UNITED STATES PATENT AND TRADEMARK OFFICE

APPLICATION NO.	FILING DATE	FIRST NAMED INVENTOR	ATTORNEY DOCKET NO.	CONFIRMATION NO.
09/788,420	02/21/2001	Oh Nam Kwon	8733.388.00	5851

Office Action Summary	Application No.	Applicant(s)
	09/788,420	KWON ET AL.
	Examiner	Art Unit
	George Y. Wang	2871

DETAILED ACTION

FIG.2

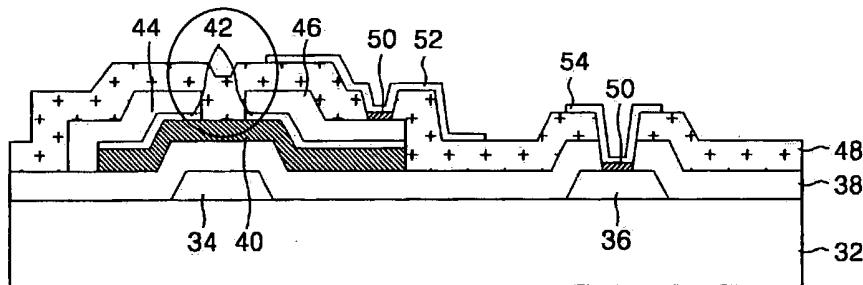
Applicant's first argument is that the second insulating layer of the Wakai reference does not teach "a hole exposing a portion of the third conductive layer." However, Examiner points out that Applicant's figure lacks a depiction of a conventional "hole." See Fig. 2 below:

Because the drawings do not show this "hole" feature as specified in the claims, Examiner has construed this "hole" to be a protrusion or filler that exposes the third conductive layer. Thus, Applicant's argument that the reference does not teach a "hole" is not persuasive since Applicant himself does not illustrate this claim. In fact, this "hole" limitation must be shown or the feature(s) canceled from the claim(s). No new matter should be entered.

F I G. 8

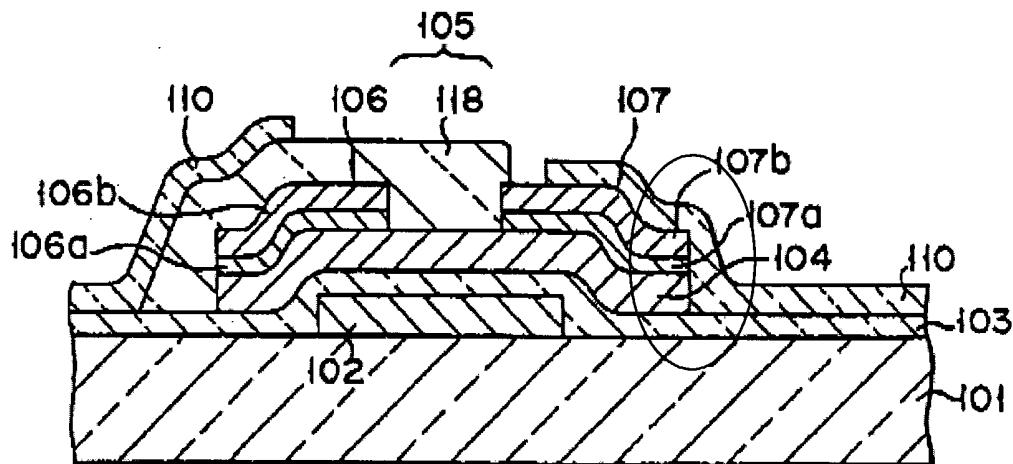
Applicant's second argument is that the Wakai reference does not disclose a fourth conductive layer on the second insulating layer and electrically contacting the third conductive layer. Examiner asserts that the Wakai reference does teach this in Fig. 8. See circled area below.

Accordingly, Applicant's arguments are not persuasive. The Wakai reference clearly teaches all the claimed limitations. Therefore, Examiner, holds to the validity of the Wakai reference and maintains rejection.
